REMARKS

10/633,323

Annotated Marked-Up Drawing

Fig. 1
~~(S.D.T.)~~
PRIOR ART

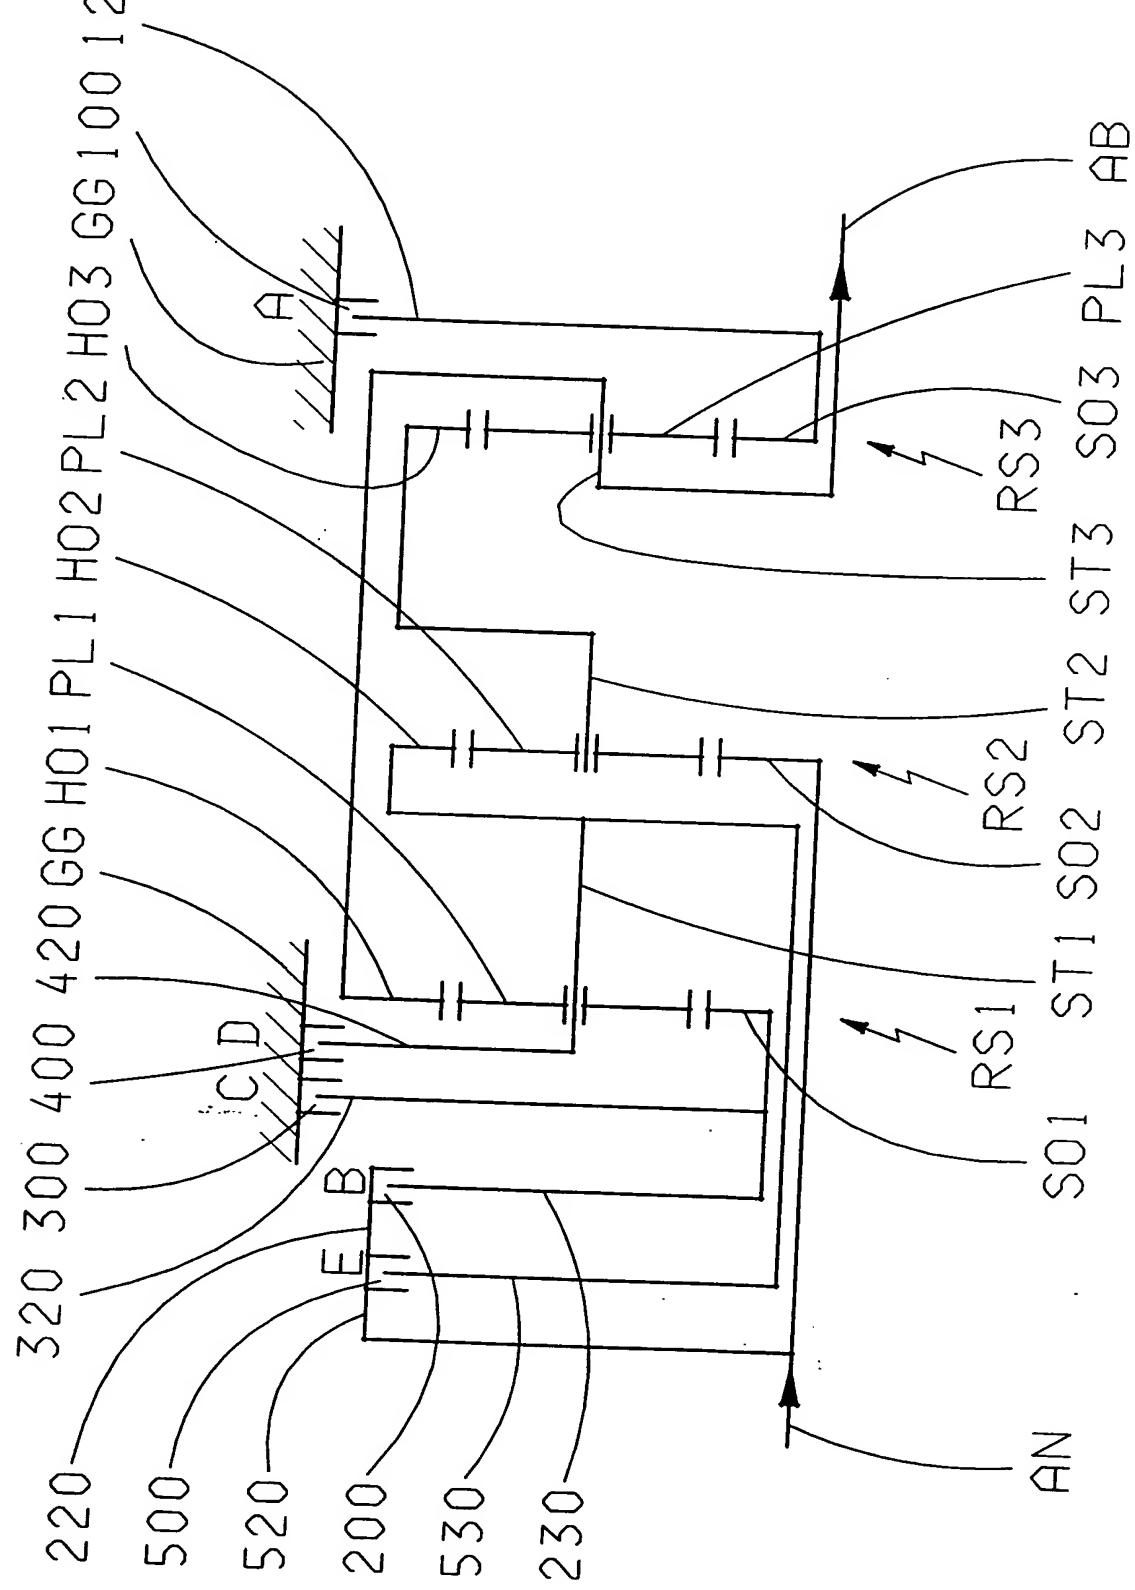
The drawings are amended, per the attached Submission, to overcome a few noted informalities contained therein. **New formal drawings, incorporating the requested amendments, are enclosed.**
